AEROSTAR INTERNATIONAL, INC.

SERVICE LETTER 110

SUBJECT: Modifications to the Aerochute vent/deflation system in S-81A.

S-81A Aerochute Retrofit Instructions

DETAIL CT

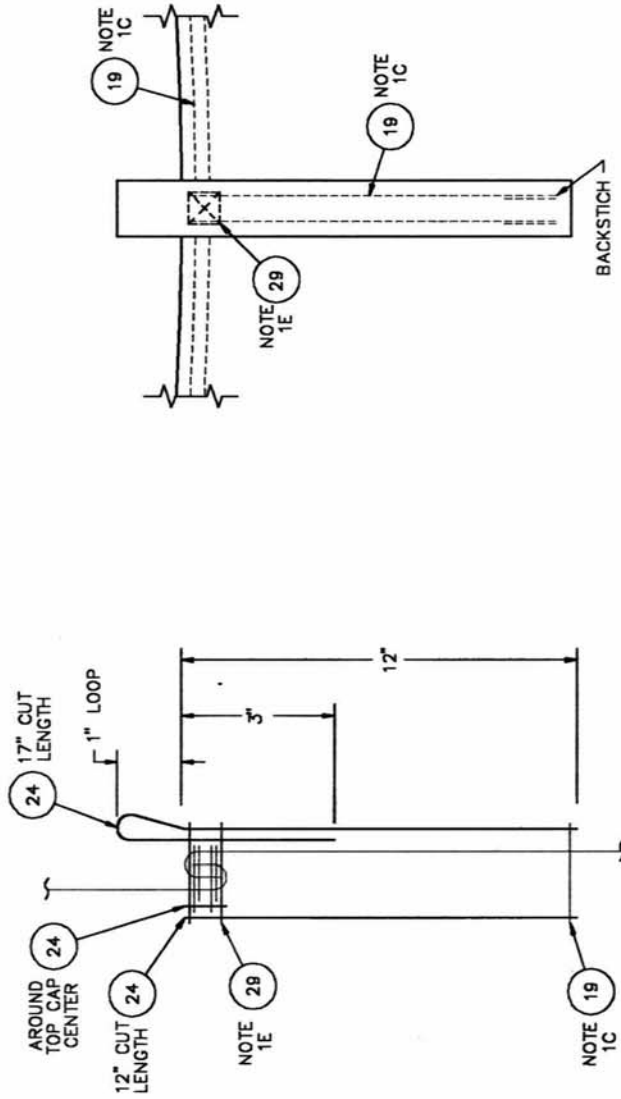
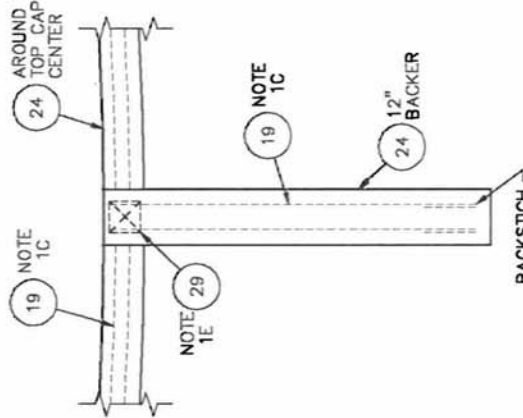
Top Cap: (Refer to Pages II & III) Install center tabs, center tab backers and 1" webbing around the perimeter of the top cap nucleus. (See drawing "DETAIL CT")

DETAIL ZA2
TOP PORT
AEROCHUTE

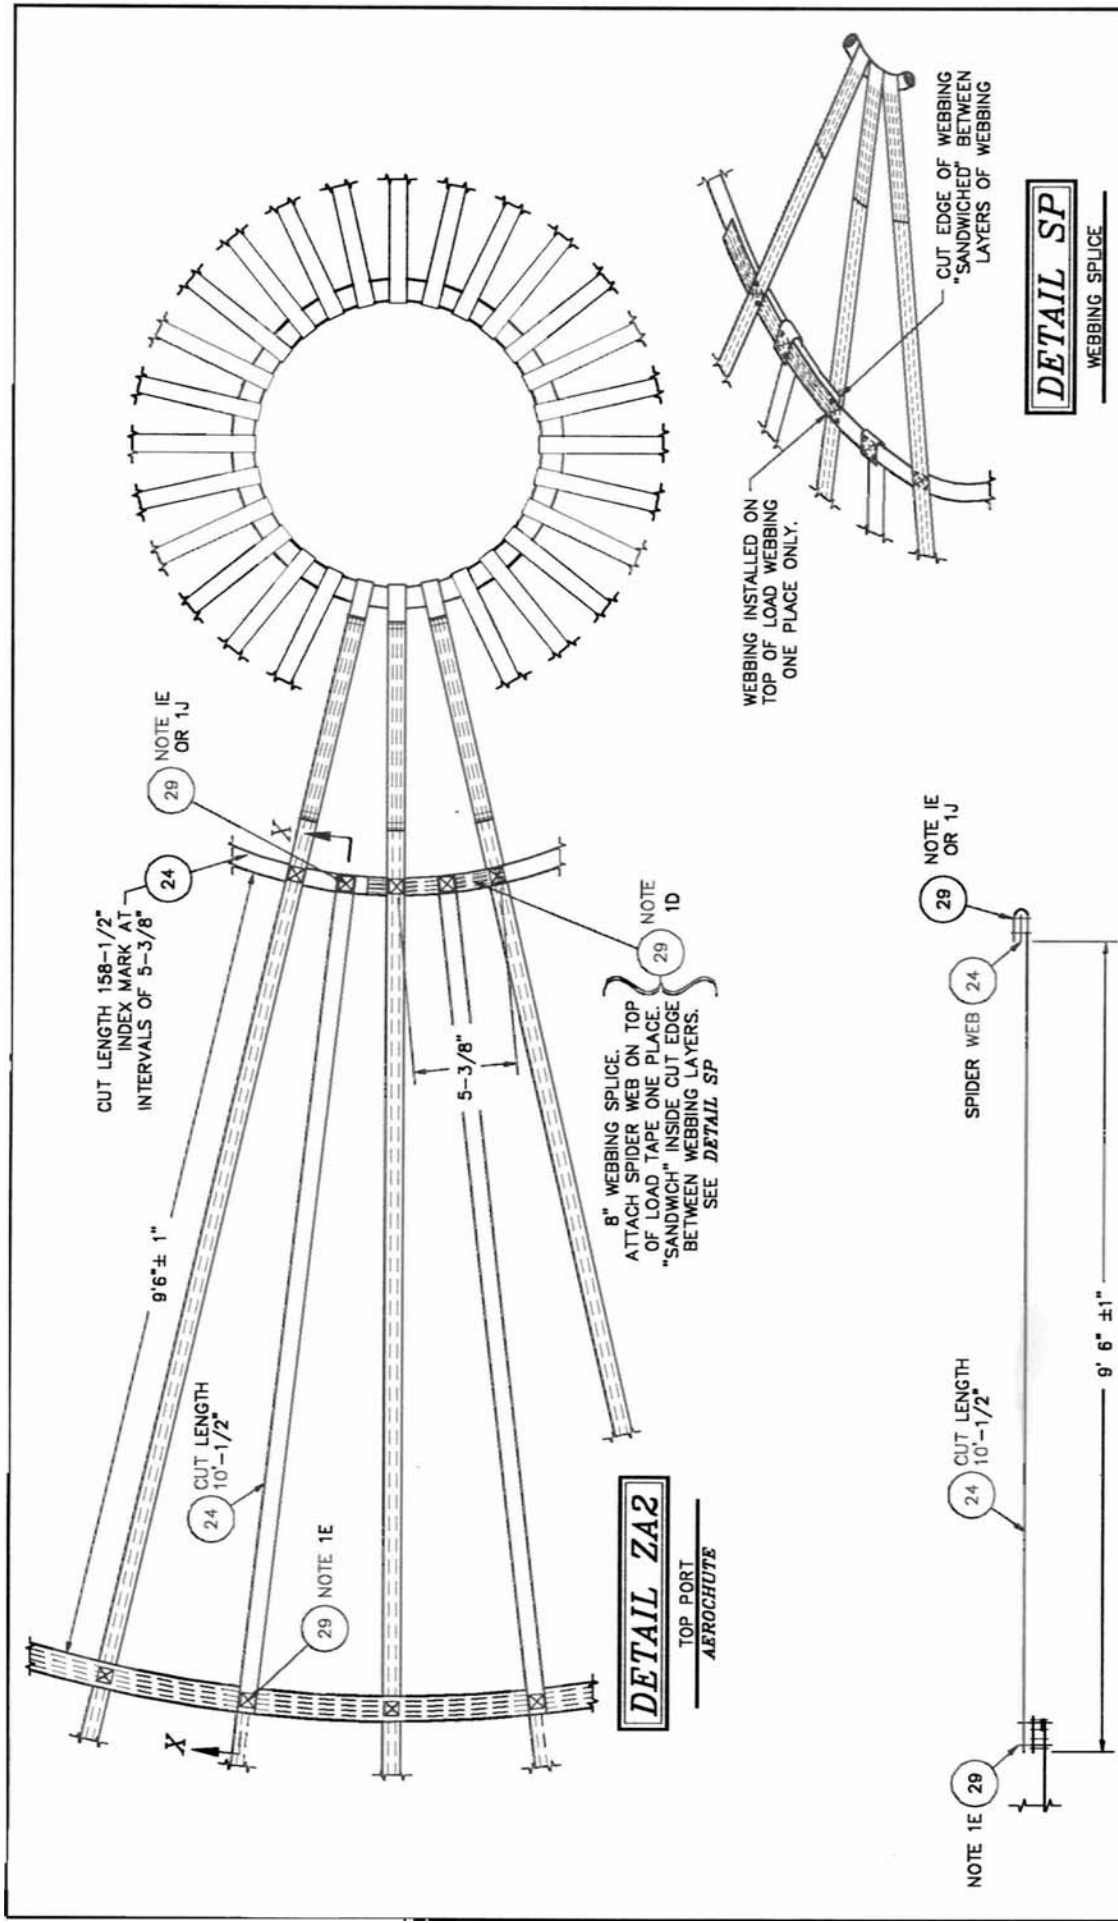
Overstraps: (Refer to Pages IV) Remove all original spider web bands attached to overstraps. Be careful not to damage overstraps.

Install new small spider web with additional overstraps to original overstraps. Sew new spider web to underside of the original overstraps except at the 8" splice (Page IV, Note 1D). "Sandwich" cut edge between webbing layers. Sew loose end of additional overstraps to port edge. (See drawing, "DETAIL ZA2" Note 1E)

PAGE V

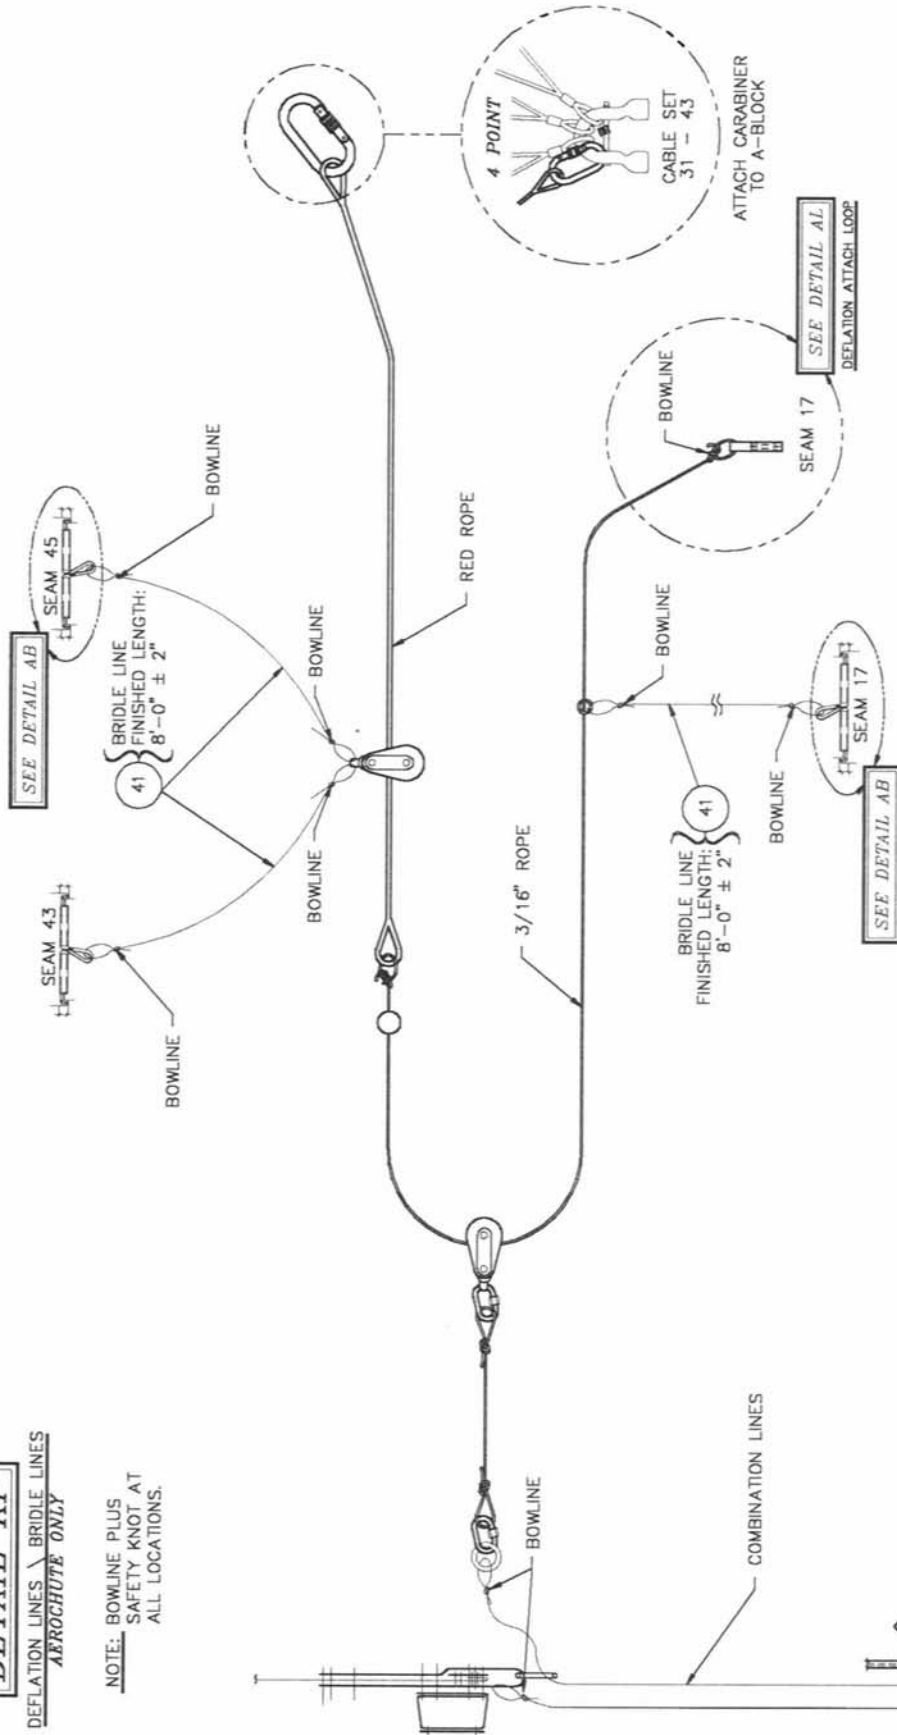
Aerochute Deflation - Vent Pull Assembly: (Refer to Page V, VII) Install deflation attach loop on "seam 17"; top of loop at "station 19", (See drawing "DETAIL AL" page VII). Install one bridle anchor on "seam 17, station 41" (See drawing, "DETAIL AB" page VII). Install single 8 foot bridle line with guide ring. Install 2 bridle anchor loops, "seams 43 and 45" at "station 49.0" (See drawing, "DETAIL AB" page VII). Install 8ft. Bridle cords and pulley.

Route vent pull line assembly as specified on Page V. (Note * Lines stay on the inside of all rotator lines.)

DETAIL KG
 CENTER TOP CAP PULL
 AEROCHUTE ONLY

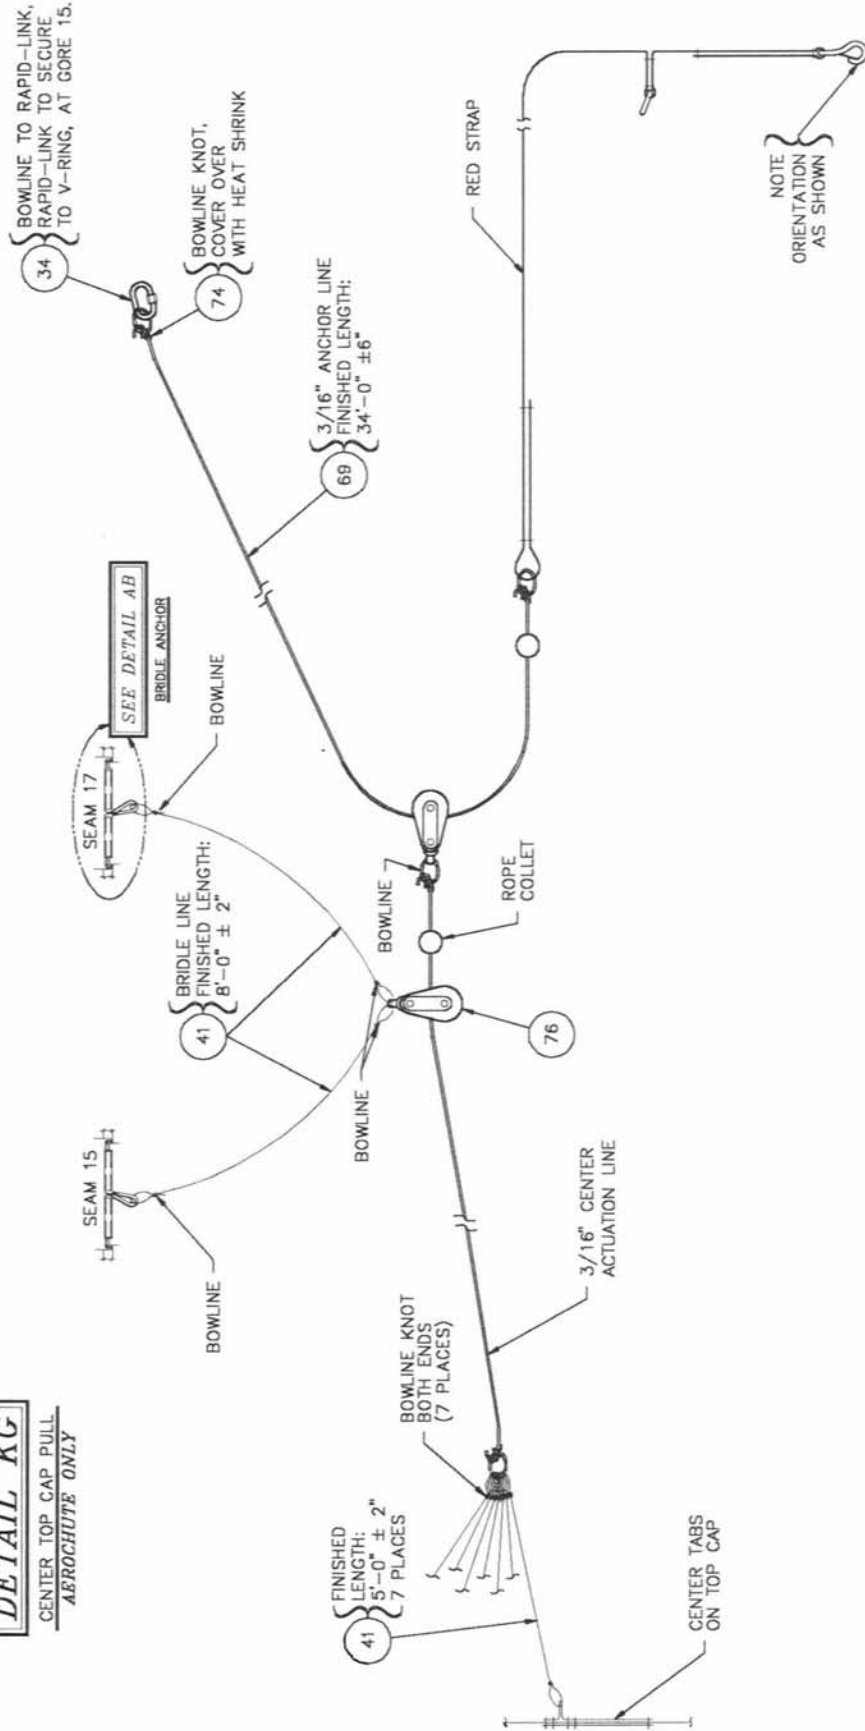
Aerochute Center Pull Assembly: (Refer to Page VI, VII) Install (7) center pull cords to top loop of center pull rope and to new center tab loops on inside of top cap.

Route top cap center pull line assembly (See drawing “**DETAIL KG**”, page VI).

DETAIL AB

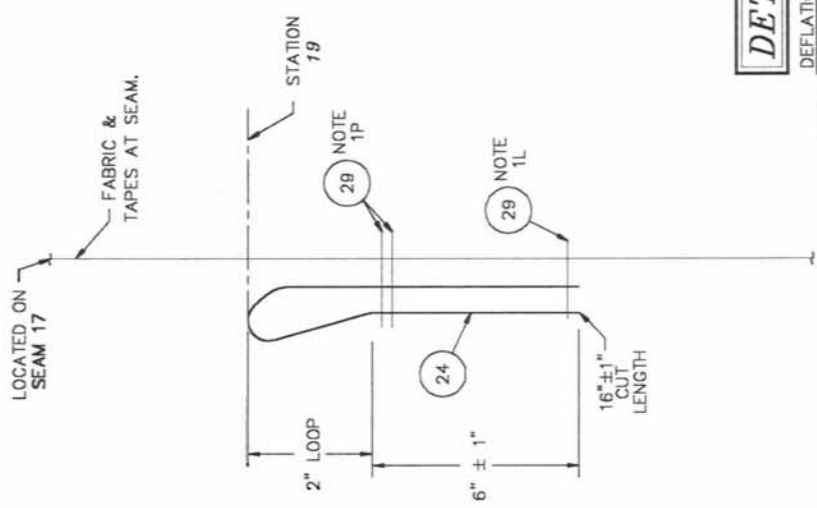
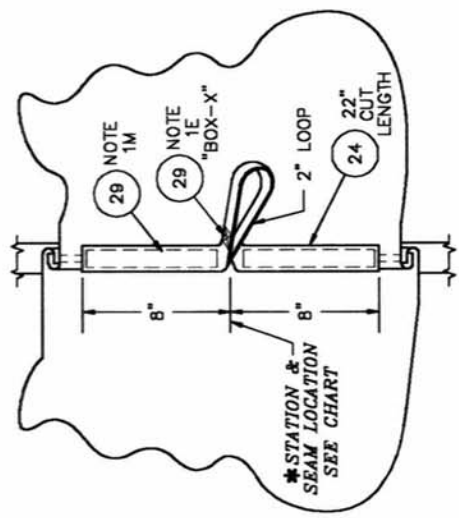
Install bridle anchor loops on “seams 15 and 17” at “station 49” (See drawing, “**DETAIL AB**” page VII).
